November 4, 2014

**BOARD OF COUNTY COMMISSIONERS
ORANGE COUNTY, FLORIDA
Addendum No. 2, IFB Y15-719-SB**

John Young Community Park

C302

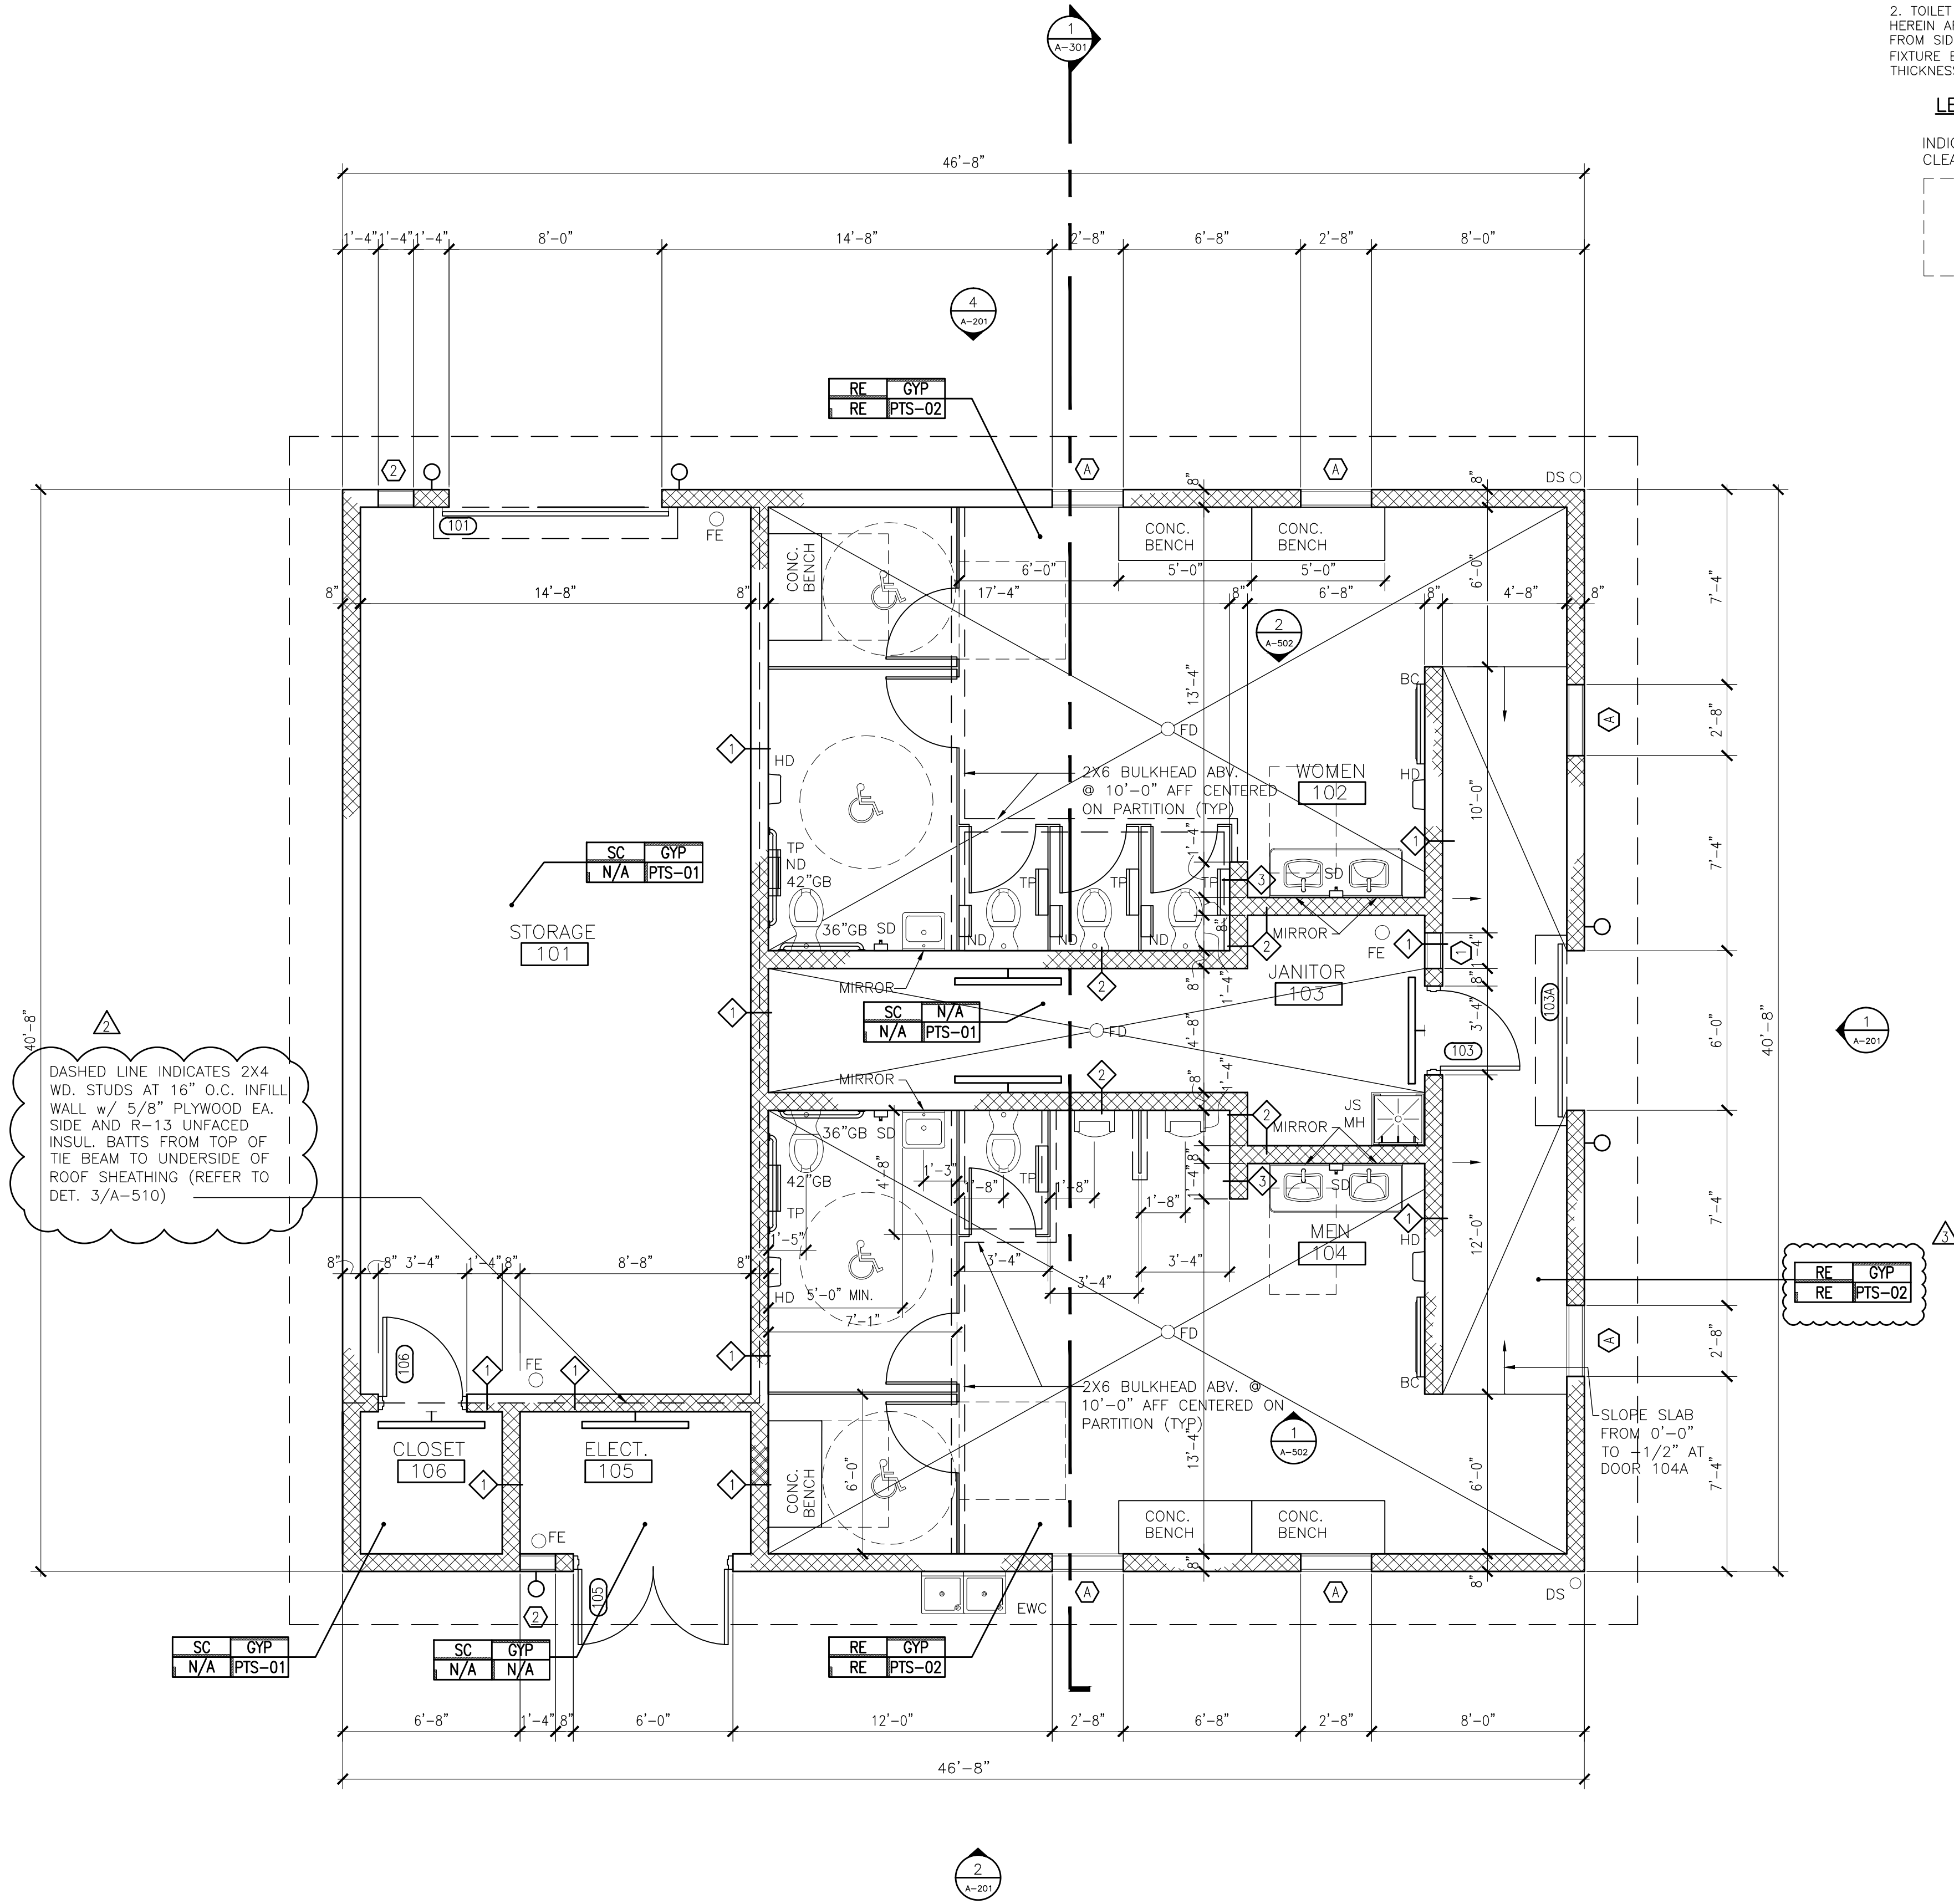
- 1. Addition:** The following sheet has been added to the documents prepared by CT HSU + Associates, P.A. - Utilities Plan, Sheet C302 dated 10-15-2014 attached.
- 2. Question:** Specifically referencing the sports field on Sheet C204, Are you plans to level the area with onsite soil and have no Import soil? If you do want Import Soil for the Sports Fields what would you like the specifications to be?

A-101

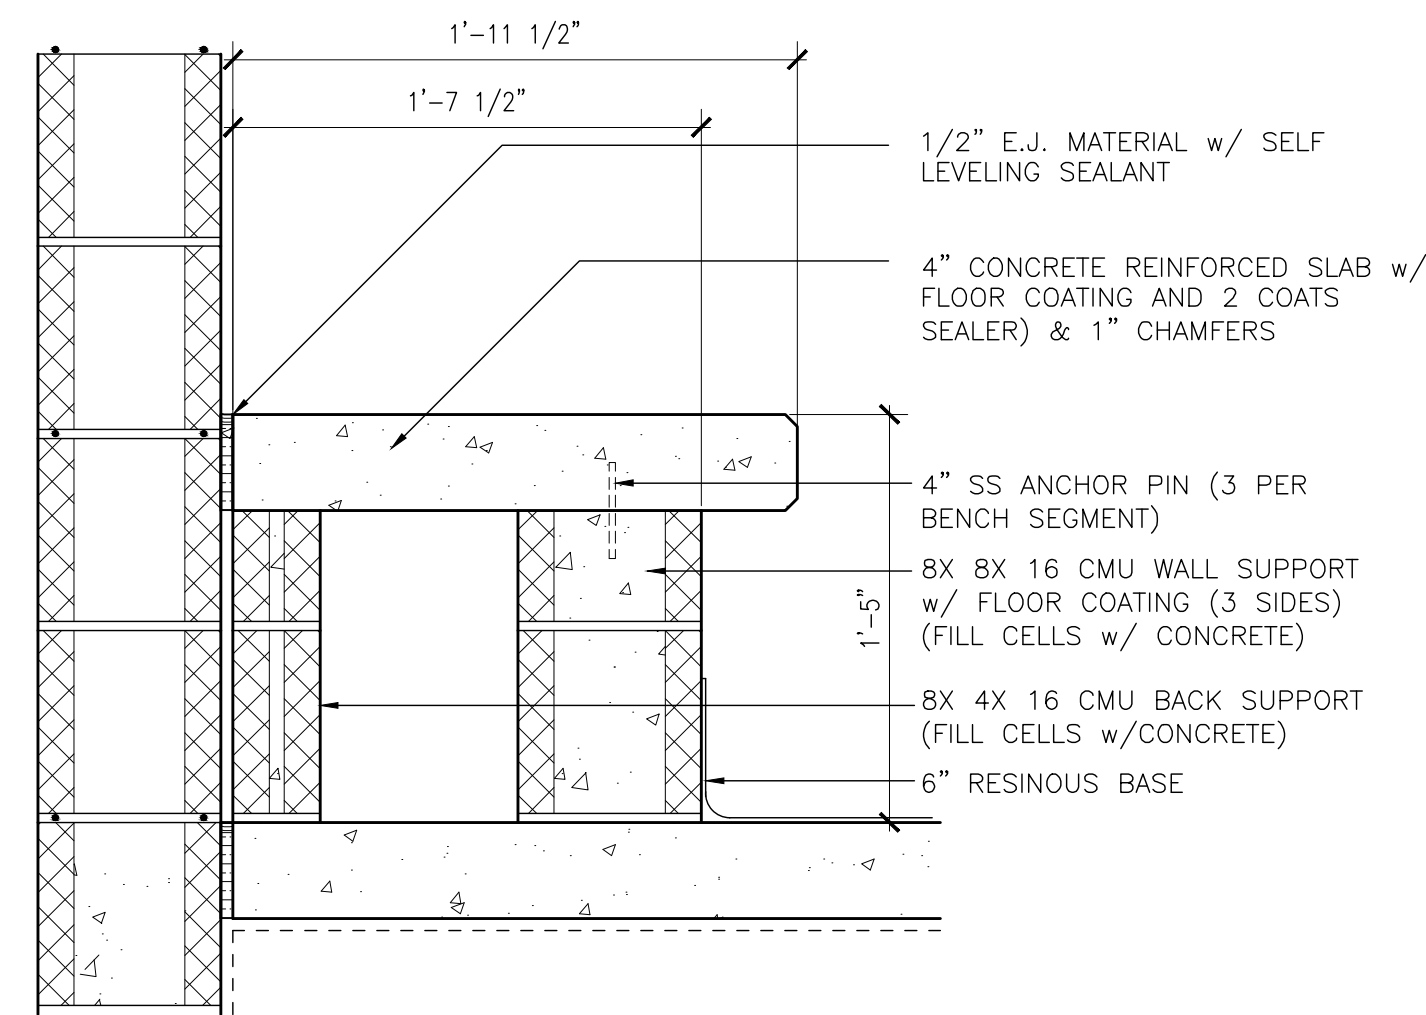
- 9. Question (NOTE: THIS QUESTION AND ANSWER PERTAINS TO THE RESTROOM/STORAGE BUILDING DOCUMENTS BY BORRELLI ARCHITECTS):** In reference to the Architectural Drawing A-101, there is a note that requires the installation of: "2x4WD. Studs at 16"O.C. Infill Wall w/5/8" Plywood @EA. Side and R-13 Unfaced insul. Batts From top of tie beam to underside of roof sheathing at the Storage Room (101)." There is a discrepancy between the Note and the drawing. Drawing indicates to install 8" CMU w/CoreFill Insulation. Please clarify which system we should use or if it is required to use both systems at that specific area. Please provide a detail and/or wall section.

- 10. Question (NOTE: THIS QUESTION AND ANSWER PERTAINS TO THE RESTROOM/STORAGE BUILDING DOCUMENTS BY BORRELLI ARCHITECTS):** In reference to Architectural Drawing A-101. We would like to know what type of paint finish and flooring is required for the area in front of the Janitor Area and between the Women and Men's Restroom Entrance. Shall the same floor finish at Janitor room apply to this area? Please advise.

Answer: There is no discrepancy in the drawings. Please refer to A-001 for the extents of wall type 1. The wood stud wall is from the top of tie beam to underside of roof sheathing as indicated. For clarity, a detail has been added to 3/A-501 and also a reference to this detail to the indicated note on A-101. See the attached revised sheets A-101 and A-501 dated 10-31-2014.

Answer: The flooring for the entry to the Men's and Women's room is a part of both rooms. Refer to wall type 1 for extents of wall. See attached revised sheet A-101 dated 10-31-2014, which adds a finish symbol to sheet A-101 to clarify the finish for the floor and walls.

ACCESSORY MOUNTING HEIGHTS

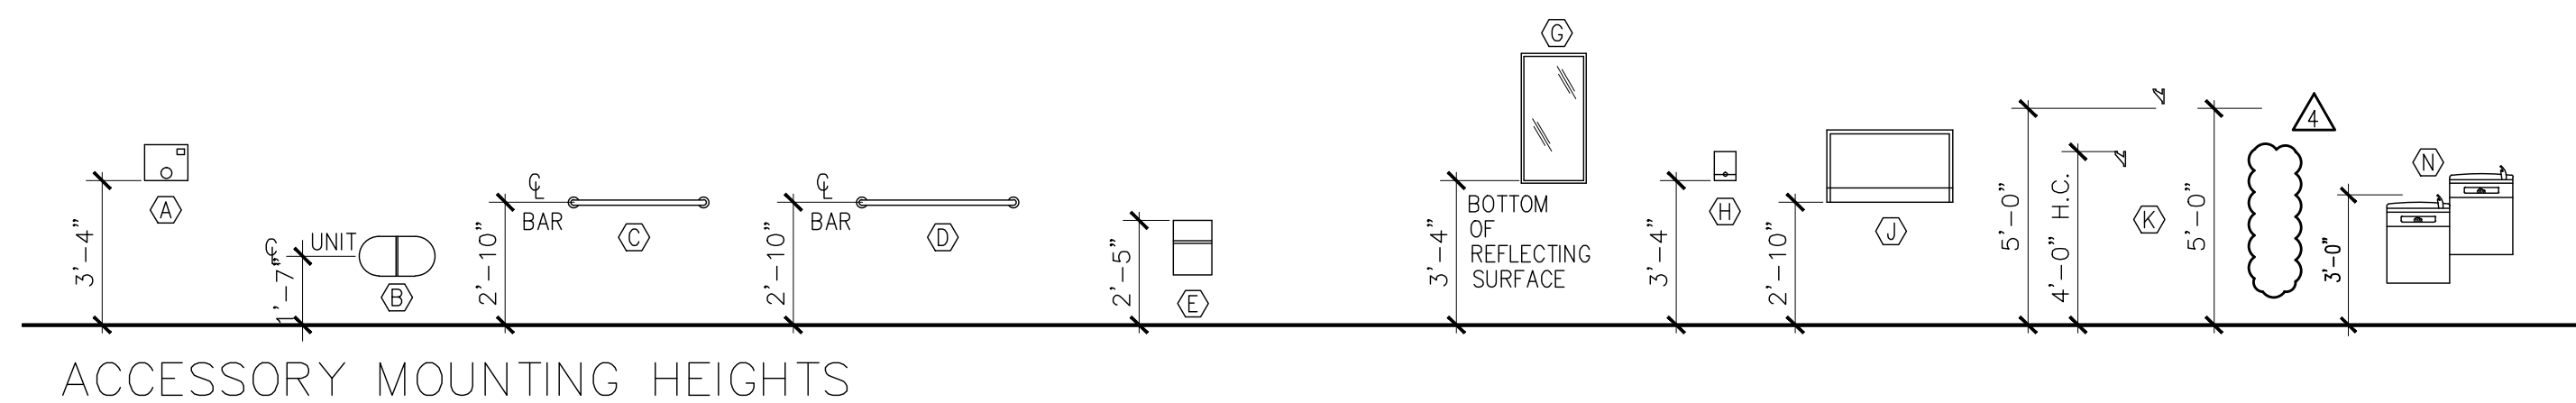
8. **Question (NOTE: THIS QUESTION AND ANSWER PERTAINS TO THE RESTROOM/STORAGE BUILDING DOCUMENTS BY BORRELLI ARCHITECTS):** In reference to Architectural Drawing A-501. The Accessory Legend box shows a Robe Hook (RH) and a Shower Curtain that we cannot find on the drawing to be quantified. Please, provide the quantities and specifications of the mentioned items.

Answer: There is no robe hook or shower curtain to be used on John Young which is not called for on the plan. See the attached revised sheet A-501 dated 10-31-2014, which clarifies this on the Accessory Mounting Heights.
